BEAVER VALLEY - UNIT 1

PROPOSED WORDING

SAFETY EVALUATION

Proposed Change Request No. 95 amends the Beaver Valley Power Station, Unit No. 1 Technical Specifications, Appendix A concerning various administrative changes.

FIGURE 5.1-1

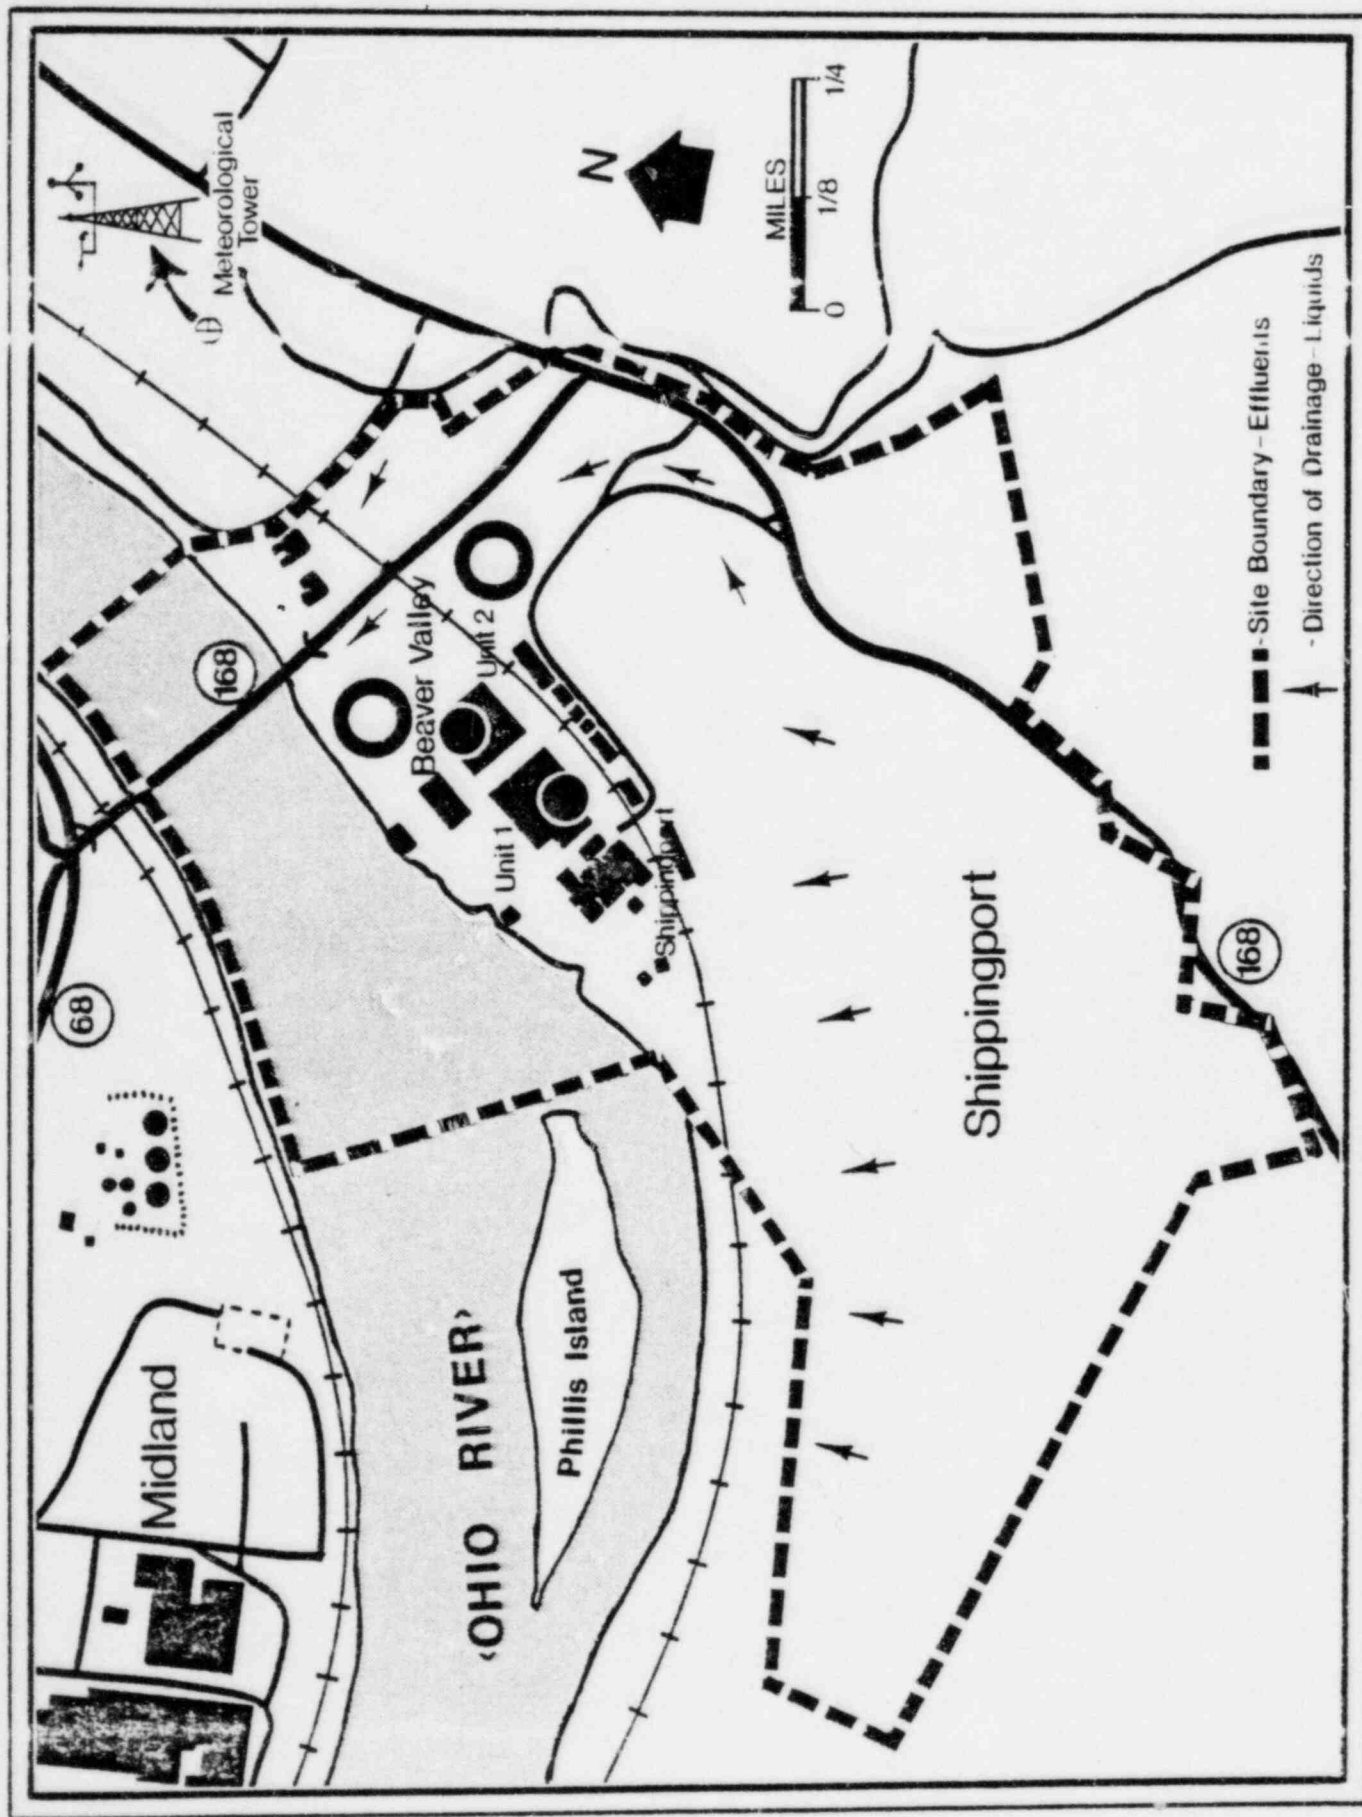
9. Figure 5.1-1 Site Boundary for Gaseous Effluents for the Beaver Valley Power Station: correct this figure by adding the "Meteorological Tower" as referenced in Section 5.8.1.
10. Figure 6.2-2, Facility Organization, has also been revised to reflect the reorganization of Station Engineering. The functions deleted from Station Engineering responsibility have been incorporated into the Nuclear Engineering Department.
11. Section 6.5.1.2 revises the title of one of the OSC members from "Senior Engineer - Station Engineering" to "Project Engineer - Nuclear Engineering Department" and adds an additional member "I&C Supervisor".

9. Figure 5.1-1 Site Boundary For Gaseous Effluents for the Beaver Valley Power Station, has been revised to identify the location of the Meteorological Tower as referenced by Section 5.8.1. This figure had been revised by the RETS (Amendment 66) and the location of the Meteorological Tower had been omitted. This change is not a safety concern and does not affect the UFSAR.
